**ADDENDUM TO REPORT OF NEAL McCARRY,
SERVICE UNIT MANAGER STRATEGIC PLANNING
DATED 26 AUGUST 2024**

SUBJECT: ITEM N0.10.4 - NSW Government's Crows Nest Transport Oriented Development rezoning proposal

Submission to the Department of Planning, Housing and Infrastructure

Crows Nest Transport Oriented Development (TOD) rezoning proposal

Figure B2.1: Building heights comparison between 2036 Plan and Crows Nest TOD at Block 3 (Source: Urban Design Report marked up by NSC)

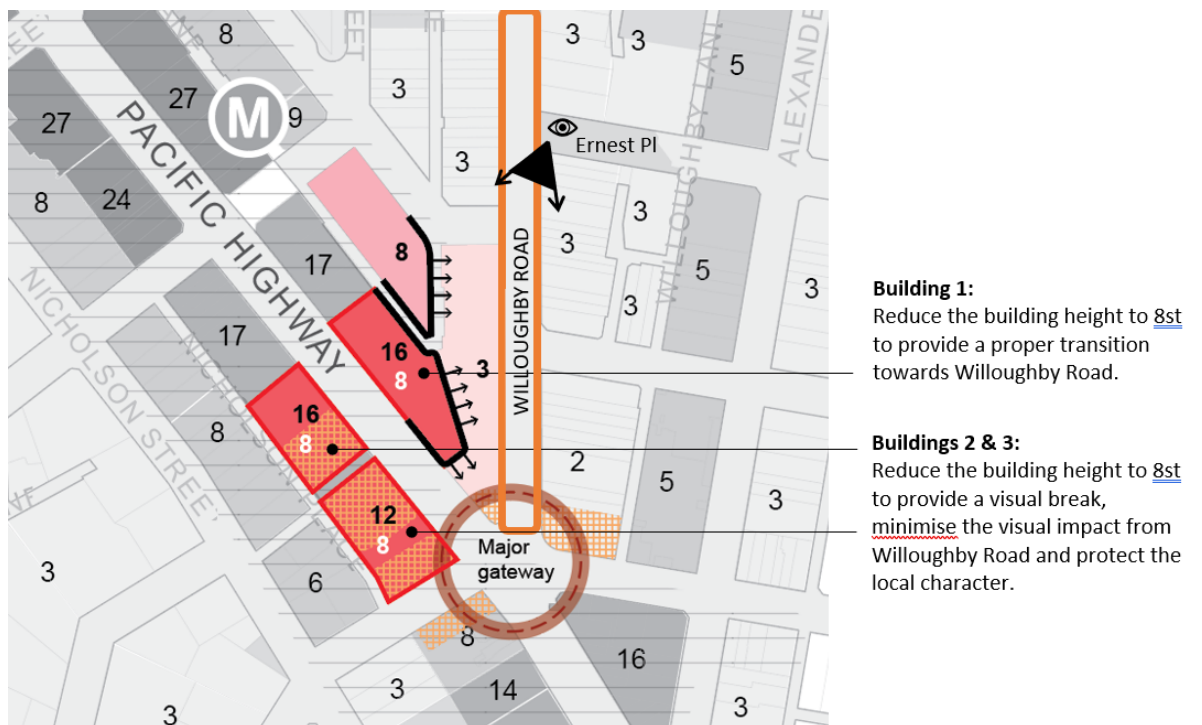
Building 1, which is located adjacent to properties fronting Willoughby Road is proposed to have its building height increased from 8 storeys (as per the 2036 Plan) to 16 storeys (refer to Figure B2.1 and B2.2).

Buildings 2 and 3, located on the south-western side of Pacific Highway, are proposed to increase in height from 8 storeys (as per the 2036 Plan) to 16 and 12 storeys (refer to Figures B2.1 and B2.2).

- Work with Council to carefully shape and locate towers to improve afternoon sunlight to Willoughby Road and Ernest Place before finalising building heights and FSR
- Reduce the maximum height limit on 437-475 Pacific Highway - Building 1 to 8-storeys
- Work with Council to carefully design the 5-Ways 'Block 3' (including Buildings 2 and 3) which are likely to better support a maximum 8-storey buildings as per the 2036 Plan
- Include a 4m above podium setback along Pacific Highway for 312-348 Pacific Highway in the Design Guide as advised in the Crows Nest TOD Urban Design Report

Figure B2.2: Building heights recommendation at Block 3

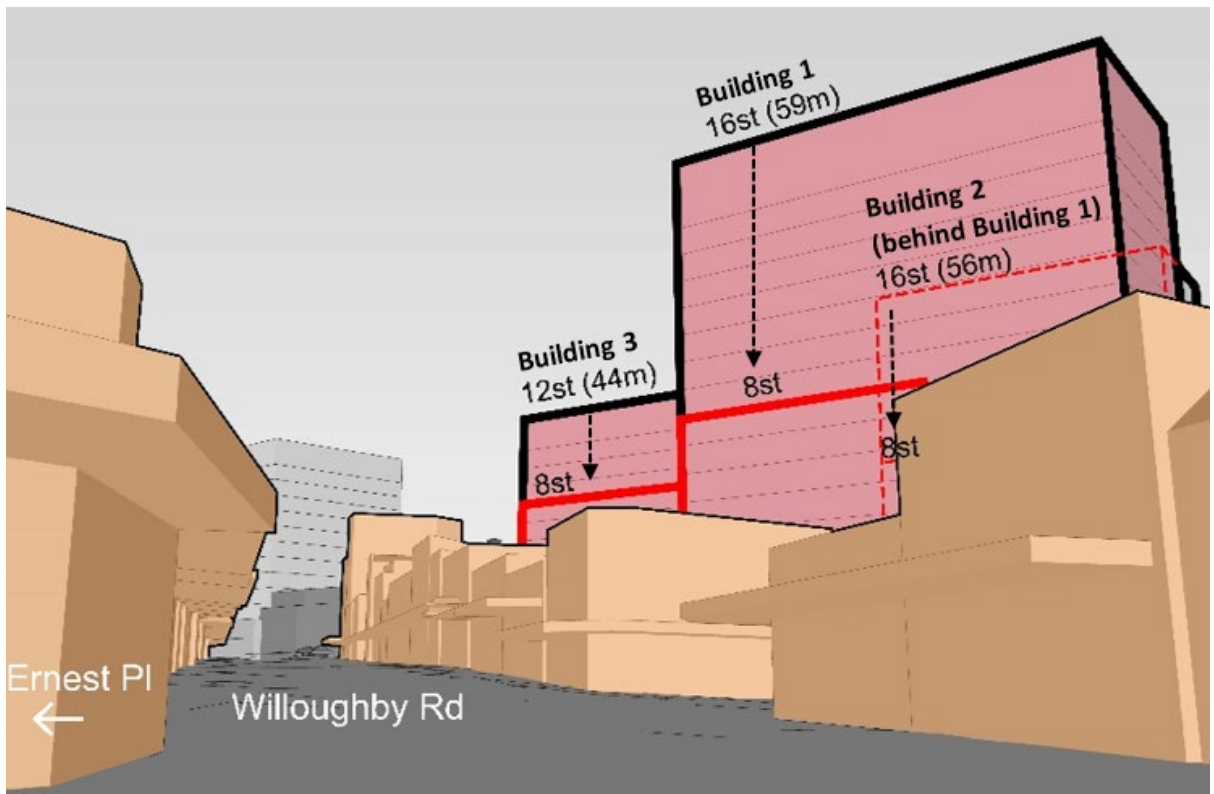
This increase would significantly alter the scale of this sensitive transition area, impacting on the character and amenity of the Willoughby Road streetscape. Figure B2.3 illustrates the view southwards along Willoughby Road, where the proposed 16-storey building would be seen directly behind the fine-grain 2-storey retail shops, creating a bulky visual impact that detracts from the existing character of Willoughby Road. In comparison, the previously proposed 8-storey building height in the 2036 Plan offers a more appropriate height transition, providing a more respectful interface and preserving the high-quality amenity of Willoughby Road.

To protect this local character and provide appropriate scaled development over this group of heritage façades, it is recommended to retain the consistent 8-storey building height from the 2036 Plan, with a 4m setback above the podium, as advised in the Crows Nest TOD Urban Design Report. This approach would largely conceal the buildings behind the development on the north-eastern side of Pacific Highway, create a visual break, respond to the heritage façades, and preserve the fine-grain local character (refer to Figure B2.3).

Figure B3.3 – Proposed building heights diagram (height in storeys) Figure B2.4 – Proposed LEP HOB map (height in metres)

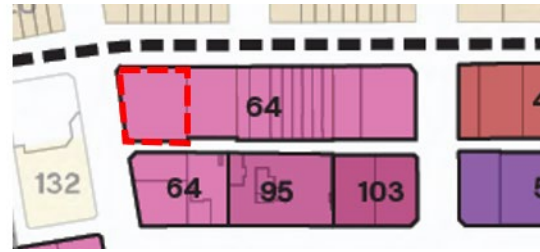
The EIE seeks to increase the maximum building height at 1 Chandos Street to 64m (the equivalent of 18 storeys), consistent with the remaining sites along the southern side of Chandos Street between Christie Street and Mitchell Street. However, the height limit is inconsistent with the anticipated number of storeys for the site, which is identified under the EIE Package and former 2036 Plan as 12 storeys.

Other sites that are envisaged to accommodate 12 storeys have been afforded a maximum height of 43m. Accordingly, a maximum 43m height limit should be applied to this site.

Furthermore, increasing the height limit to that proposed on this site would have detrimental impacts on solar access to Christie Street Reserve, which is inconsistent with the desired solar access outcomes of the EIE Package.

- The Urban Design Report be revised to apply a maximum of 16 storeys to 2 Atchison Street
- Reduce LEP building heights with affordable housing bonus at 360-376 Pacific Highway and 378-390 Pacific Highway to align with the proposed building heights in storeys; note comments at Section 3.5

Figure B7.1 – Propose setback controls map – misalignments and unsupported changes

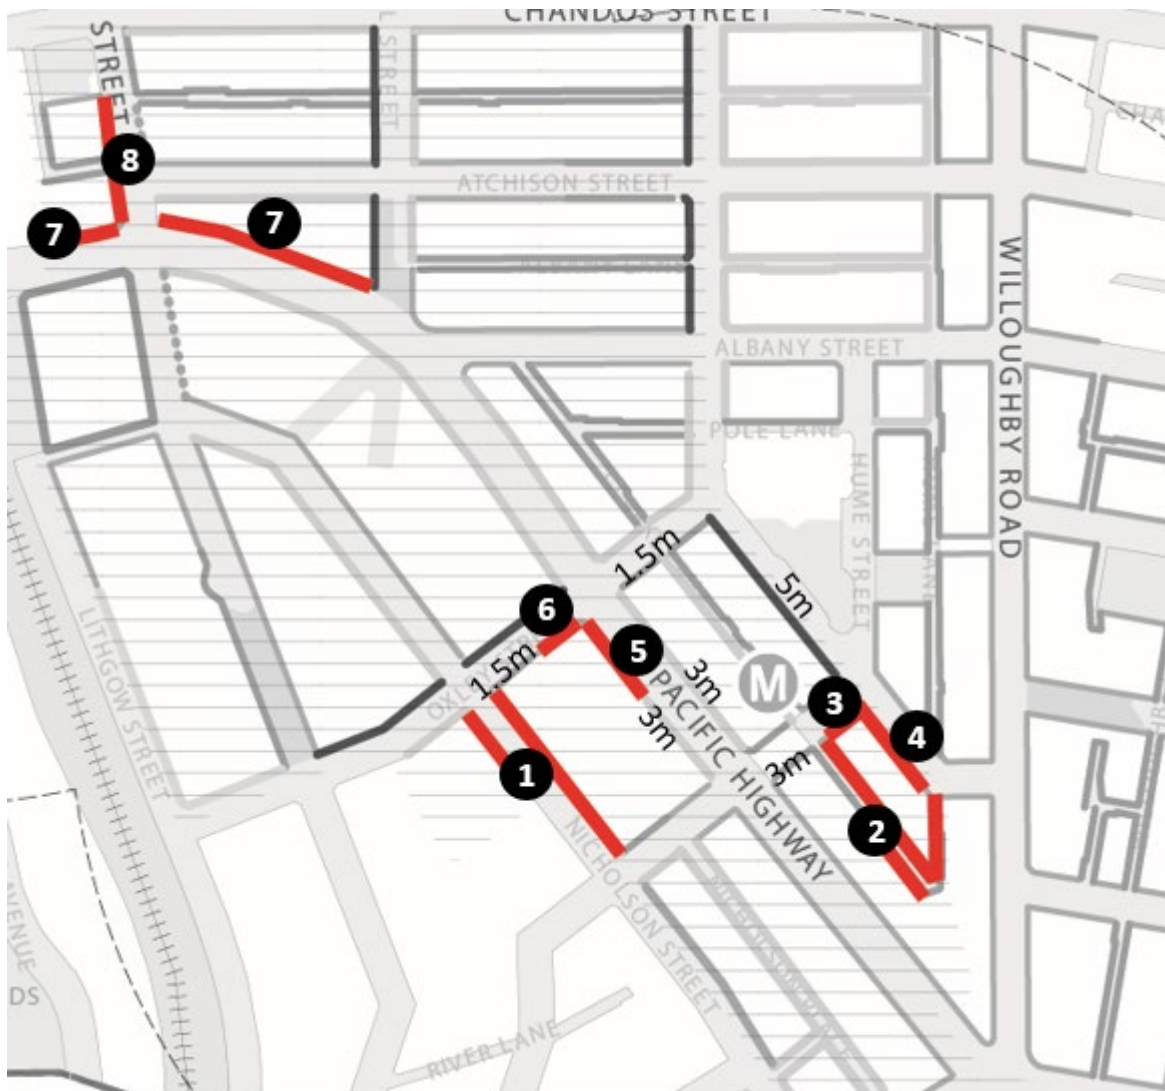
Additionally, the proposed setback controls seek to introduce several modifications in comparison to the 2036 Plan and North Sydney Development Control Plan (NSDCP 2013). Upon review, it is evident that some of the proposed setbacks are not supported as they undermine the desired character of the area and negatively impact on local amenity.

2. Clarke Lane and Hume Lane: A nil setback is proposed to both sides of the laneways. The 2036 Plan sought a 1.5m reverse podium setback along its north-eastern side, while remained silent with regards to its south-western side. NSDCP 2013 specifies a 1.5m whole of building setback to the north-eastern side of the laneways and a varied setback to the south-western side adjacent to the Crows Nest Metro site to align with the SSD Concept Approval. Implementing a 1.5m setback, especially along their north-eastern side would align with the setback further north along Hume Lane, creating a consistent street frontage. Considering the significant foot traffic generated from the Metro Station and the potential through-site link at Hume Lane, a 1.5m setback is essential for pedestrian amenity.

4. Clarke Street: A nil setback is proposed between Hume Street and Hume Lane, and 5m between Hume Street and Oxley Street. Whilst the 2036 Plan was silent, NSDCP 2013 requires a 3m setback (except for Crows Nest Metro Site C which has a 1.2m setback) to allow space for outdoor dining and landscaping. While the 5m setback is welcomed between Hume and Oxley Streets, a 3m setback should apply as it will still enable the ability to provide landscaping and pedestrian activity. In addition, implementation of a 5m setback could adversely impact on the redevelopment potential of these sites, as the depth of the lots would be reduced to approximately 22m.

5. Pacific Highway: A 3m setback is proposed on both sides of Pacific Highway between Oxley Street and Hume Street, except for the northern end of the western side, where a 0m setback is proposed. Both the 2036 Plan and NSDCP 2013 recommend a 3m setback along the entire Pacific Highway frontage for this block to provide a consistent street frontage and sufficient footpath space for pedestrians near the Metro Station. Therefore, to maximise pedestrian amenity, it is recommended that continuous 3m setback be applied.

7. Pacific Highway: A 3m setback is proposed along Pacific Highway, west of Mitchell Street. The 2036 Plan and NSDCP 2013 suggests a 3m reverse setback for the lower two ground levels in this section to allow for footpath widening and to accommodate reasonable development floorplates given the limited width of the sites. It is recommended that a reverse 3m setback be reinstated for these sites.
8. Christie Street: A nil setback is proposed along the western side of Christie Street. Whilst the 2036 Plan was silent with regard to any setbacks along this side of the street. NSDCP 2013 requires a 3m reverse setback along the western side of Christie Street to provide additional space for footpath widening near the railway station and to maintain a consistent street frontage.

- Amend the proposed setback control diagram to correct any misalignment with the section diagram and incorporate Council’s recommendations.

Figure B8.1 – Proposed street wall heights map – misalignments and unsupported changes

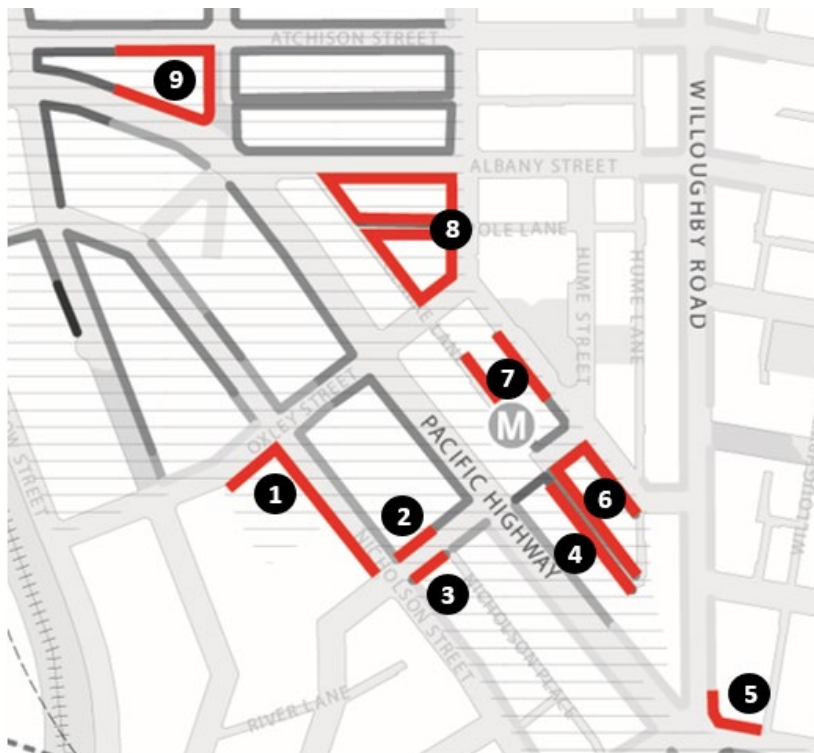
Several discrepancies are noted between the proposed podium height controls in the 3D views, sections, and control map. It is crucial that the Design Guide accurately reflects these controls.

6. Clarke Street, Hume Street and Clarke Lane: The proposed 4-storey street wall with an 8-storey building height contrasts with the 2036 Plan's recommendation of 2 storeys. Due to the site's topography, NSDCP2013 suggests 3 storeys along Clarke Street and Hume Street, and 2 storeys along Clarke Lane. Aligning with NSDCP2013 is recommended for a smoother transition to Willoughby Road.

8. Oxley Street, Albany Street, Clarke Lane and Pole Lane: The proposed 6-storey street wall exceeds the 3-4 storeys of existing buildings as per NSDCP2013. Most sites here are recently built and already comply with the 2036 Plan. The podium heights should be adjusted to match NSDCP2013.

- Amend the proposed street wall height control diagram to correct misalignments with the 3D views and section diagrams and incorporate Council's recommendations.

Figure B10.1 – Hume Street Park

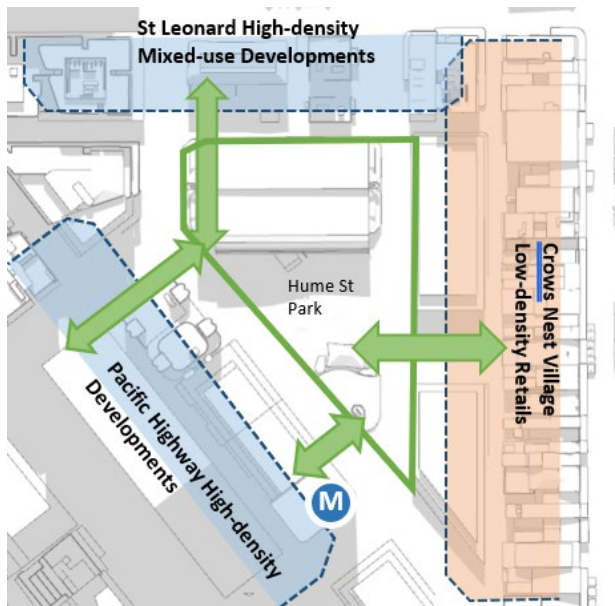
It is evident that the proposed uplift to the Lot 4B development site in the Willoughby LGA, will have a significant impact on Wadanggari Park, located on the southern side of Pacific Highway atop the railway line. The resulting increase in density on this site will cause additional shadowing, especially between 2pm and 3pm in mid-winter (see Figure B10.2), resulting in this Park only achieving 50% solar access between 12pm and 1pm. Before 11am and after 2.30pm, the park will be fully shaded.

- Add clear objectives and provisions in the Design Guide to identify the public domain opportunities and related funding mechanisms to rejuvenate Hume Street Park.

Figure B22.1 - Land use map from Design Guide

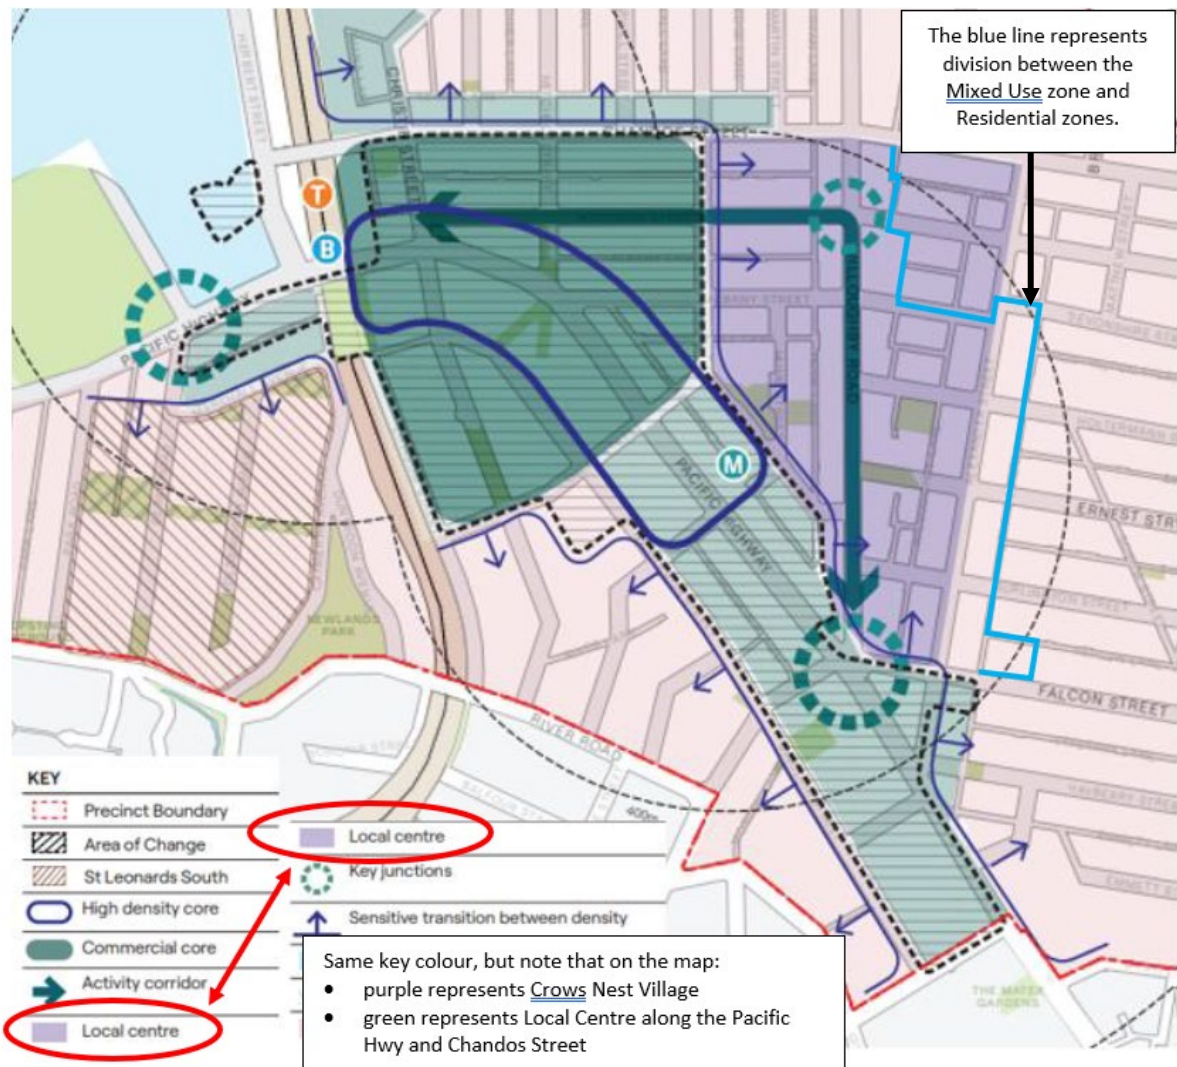
The land use map contains a number of errors in relation to the extent of the Crow Nest Village (local centre) and the key.

The Map incorrectly labels the mixed-use zones along the east side of Alexander Street between Falcon Street and Devonshire Street as residential areas. In addition, a residential area generally located between zigzag Lane, Chandos Street, Aleander Street and Albany Street is shown as part of the local centre (refer to Figure B22.1)

This error needs to be corrected to accurately reflect the intended land use.

Figure B24.1 – Built form design recommendations – Urban Design Report

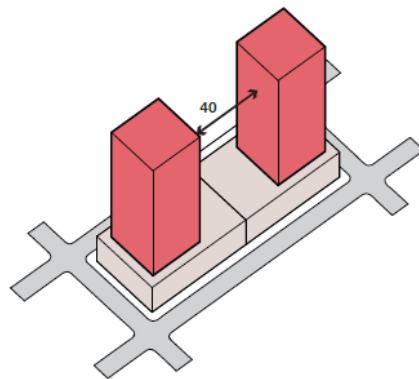
The Urban Design Report suggests a 40m separation between towers along Pacific Highway (see Figure B24.1) to enhance sensitivity to the local character and context.

To preserve amenity for Wollstonecraft residents and pedestrians, it is recommended that a new provision be provided within the Design Guide requiring:

Figure B28.1: Extract of Figure 8 to the Design Guide and extent of missing public open spaces where solar access is to be protected.

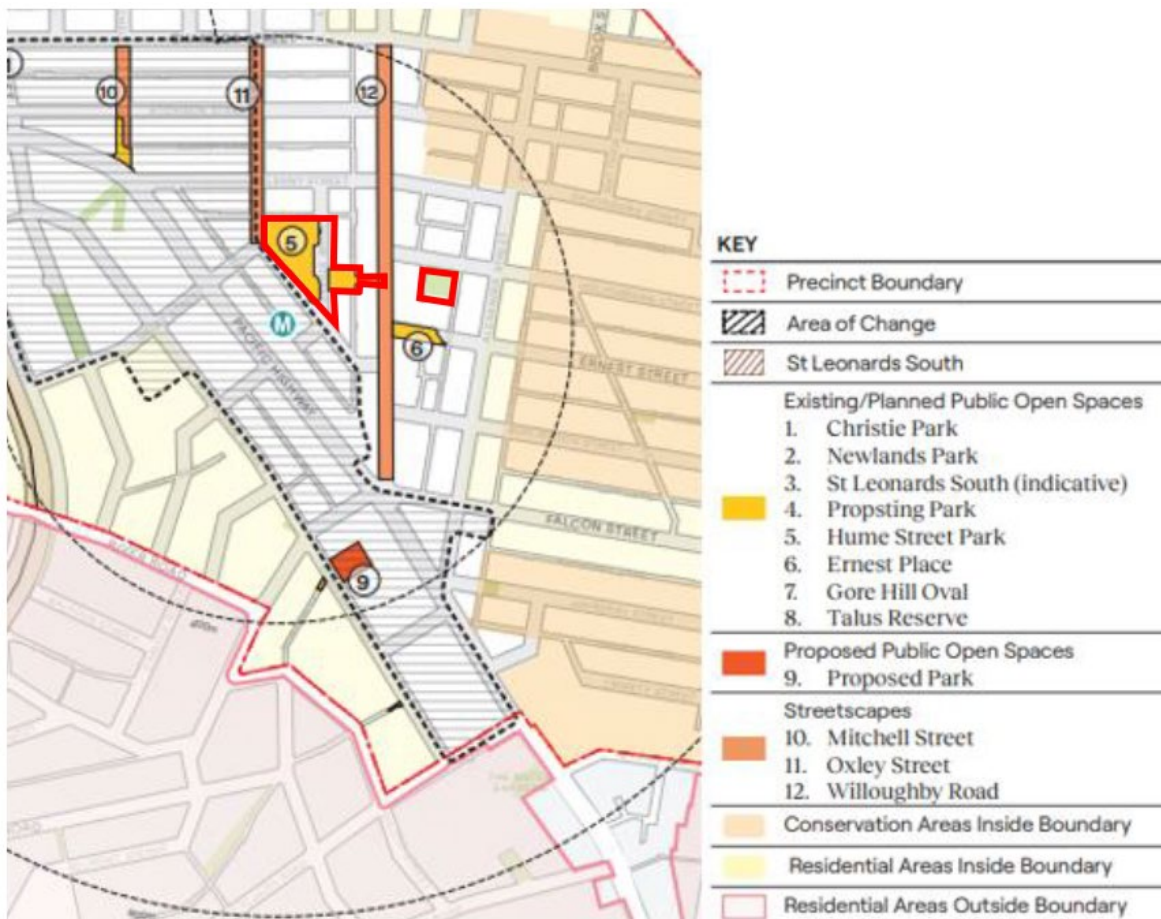
The proposed solar access map fails to correctly identify the full extent of Hume Street Park, which includes the road reserve of Hume Street. This road reserve is zoned as RE1 in the North Sydney Local Environmental Plan (NSLEP2013) and is expected to be transformed into part of Hume Street Park in the long term. The solar access map should be updated to reflect this consolidated space accurately.

Additionally, no solar access protection is being proposed for any future Holterman Street Park, as identified in the 2036 Plan. The NSDCP2013 includes a solar access protection control for this future open space. It is recommended to add Holterman Street Park to the solar access protection areas.

Figure B32.1 – Block 4 section – Urban Design Report

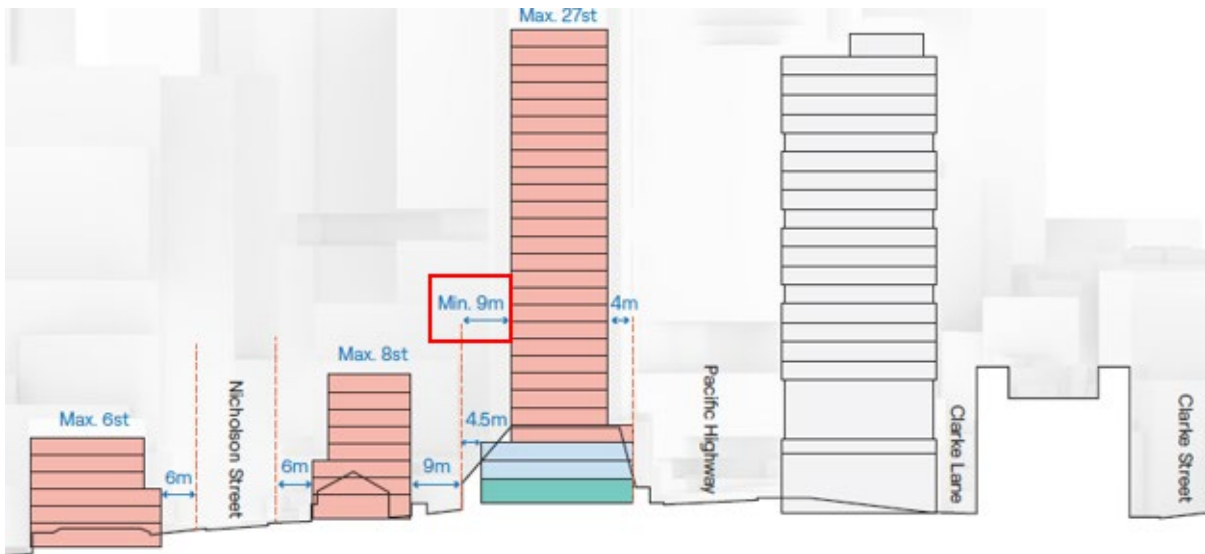
The cross sections from the Urban Design Report for opportunity blocks detail minimum tower setbacks along Nicholson Street and Sinclair Street (see Figure B32.1), which are reflected in the 3D models and align with the proposed FSR. However, these setback controls are not reflected in the Design Guide. To ensure the intended design outcomes are met, it is essential to include these minimum tower setback controls within the Design Guide.
